Tucson South Resource, M-2004-044, AM01, Adequacy Review No. 3

COLORADO
Division of Reclamation,
Mining and Safety
Department of Natural Resources

Subject: Slope Stability and Setback Updates, July 3, 2019; Tetra Tech Job No. 200-23514-18004

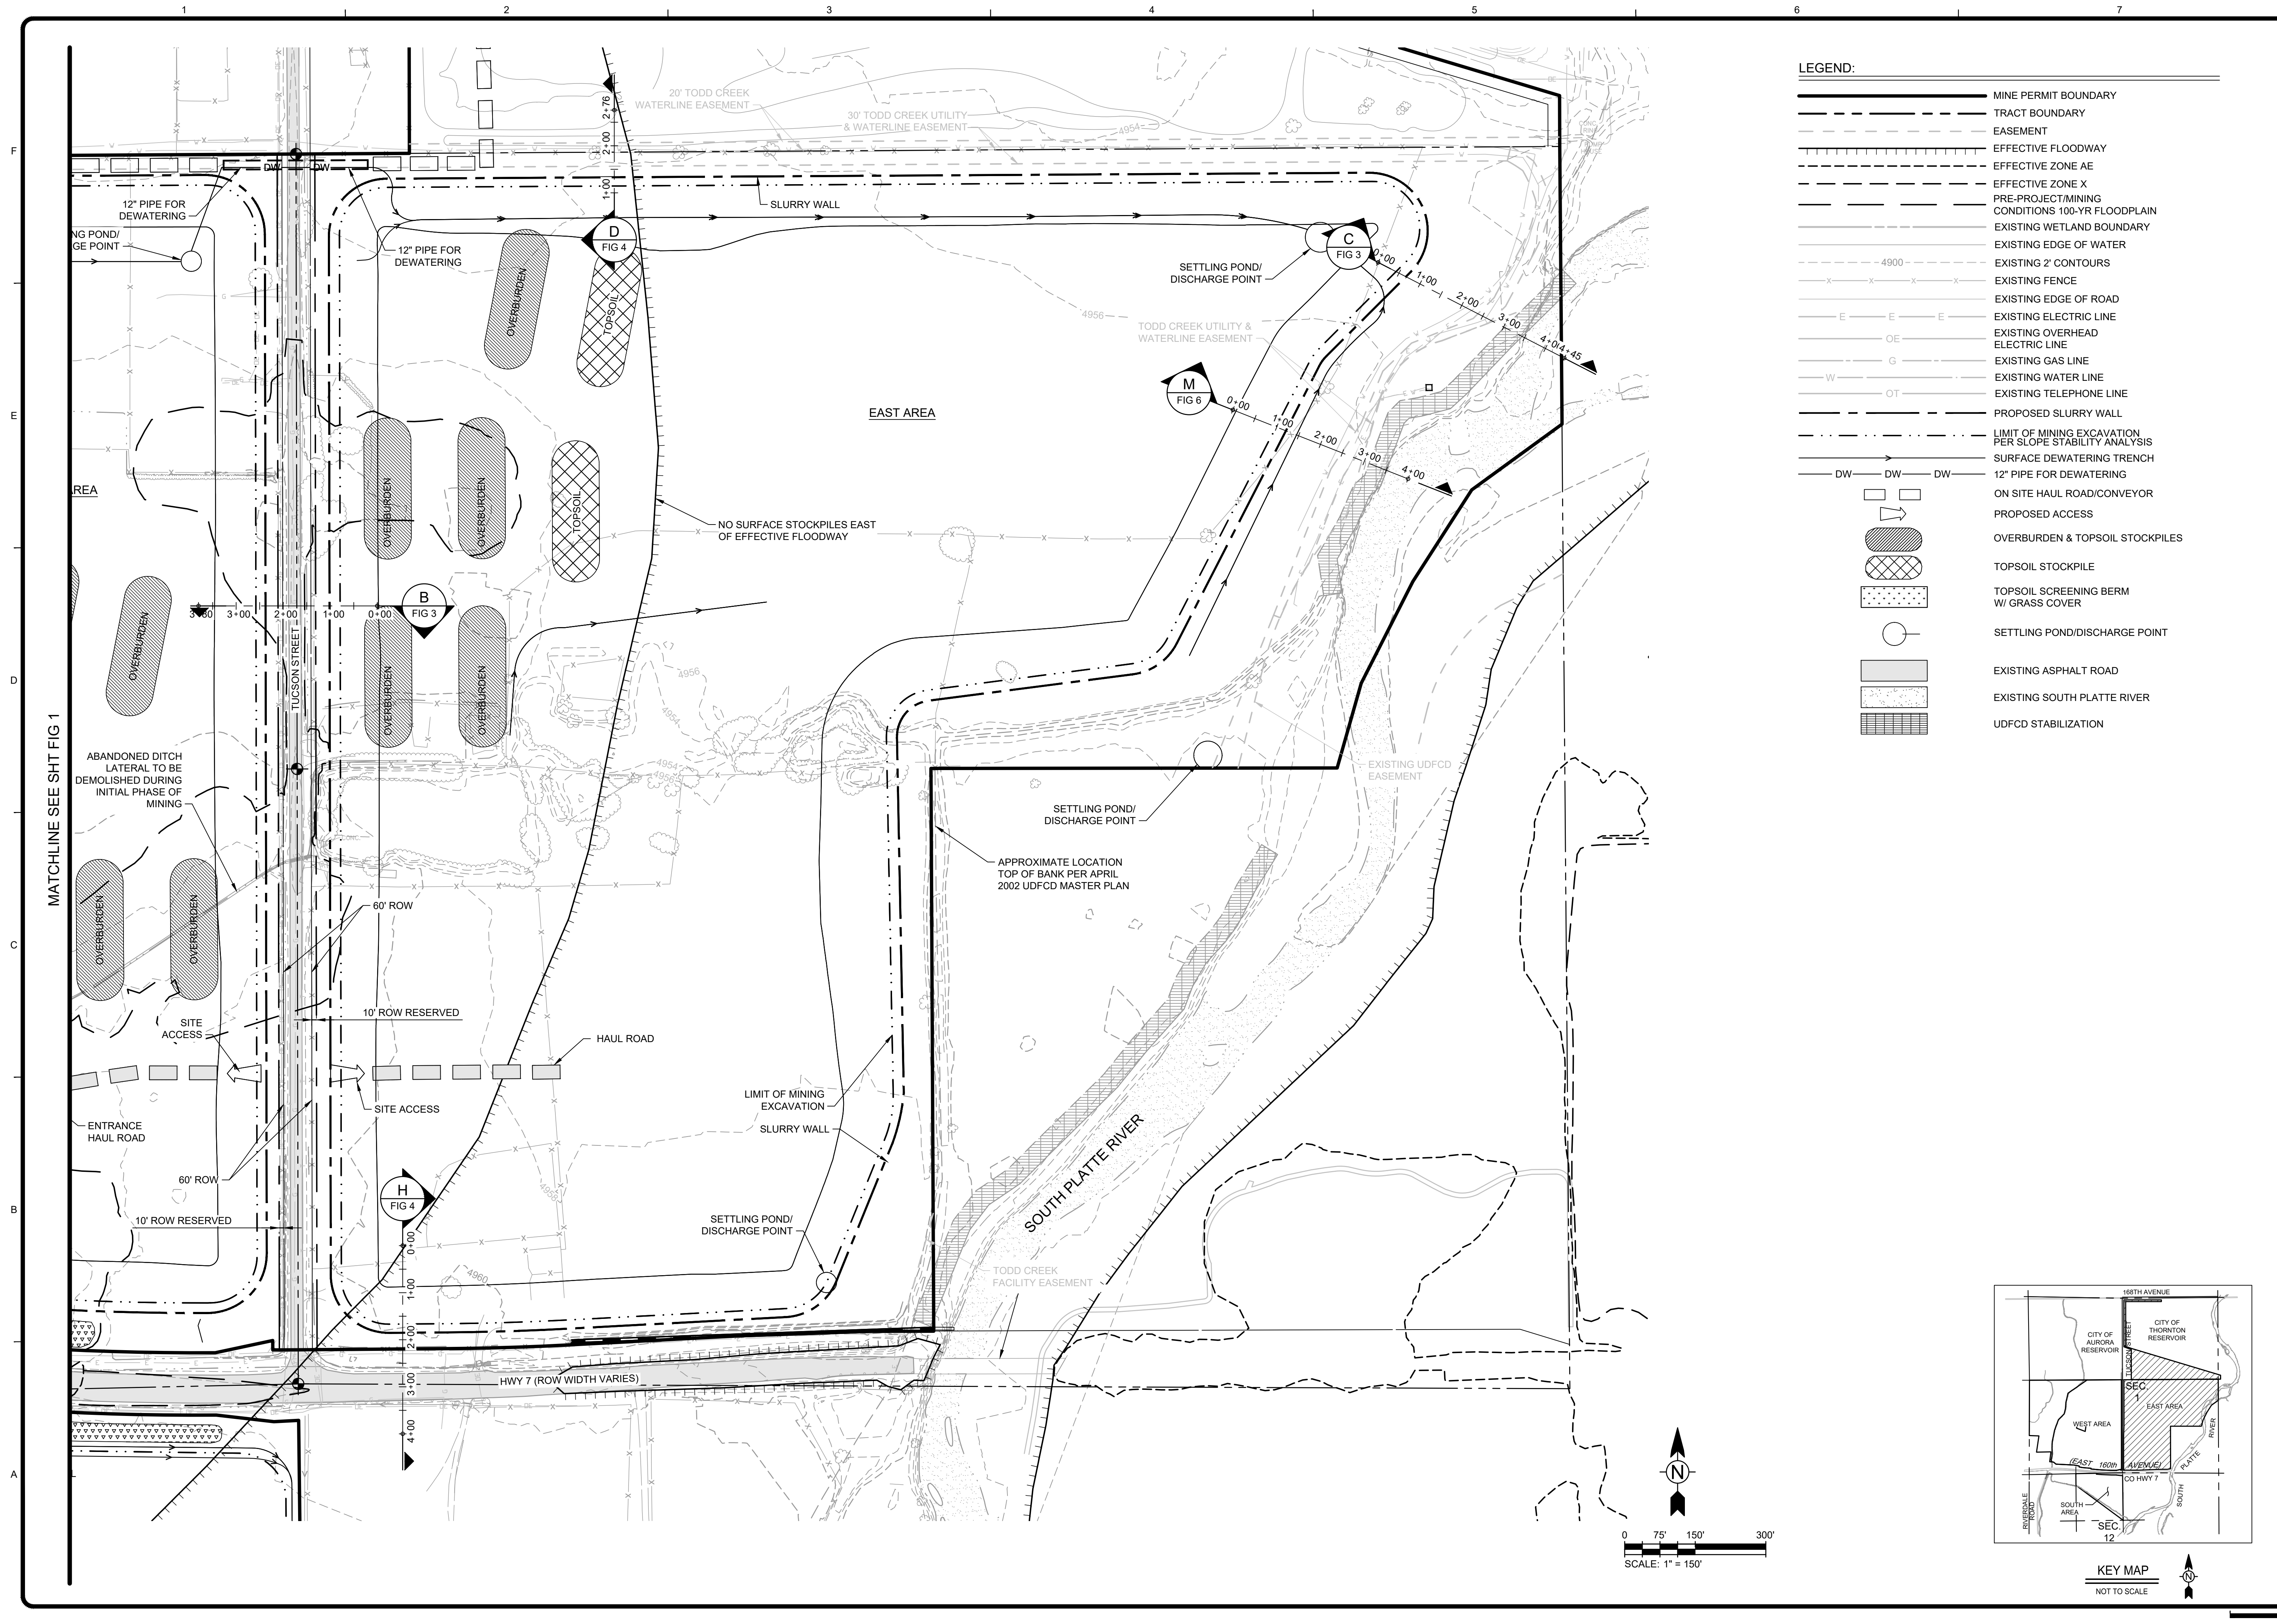
3) The slope stability memo was only updated to remove one reference to the old phasing, nothing else changed. In fact, the only change was on the mine plan figure that was included in the memo. Please see the attached redline version showing the exact area where the change was made to make it easier for your review. The Phase 1 reference on the figure is highlighted to indicate it was deleted. Hopefully that makes your review quicker and easier.

3.) I was not expecting a complete revised stability memo, this will take a significant amount of time to review. Given the decision date is tomorrow, the Division will not have time to review this revised exhibit and request that AI request an extension. Please keep in mind the Division may deny the application if we are not allowed sufficient time to review the revised material. Is there a reason this was revised and submitted?

REVISION HISTORY

9/16/2019

- Revised offset table
- Revised CAD cross section exhibits to add more detail
- Revised Slope/W cross section exhibit to add more detailed dimensions
 - Computer analysis changed for Section M only
 - Computer analysis not changed for all other cross sections
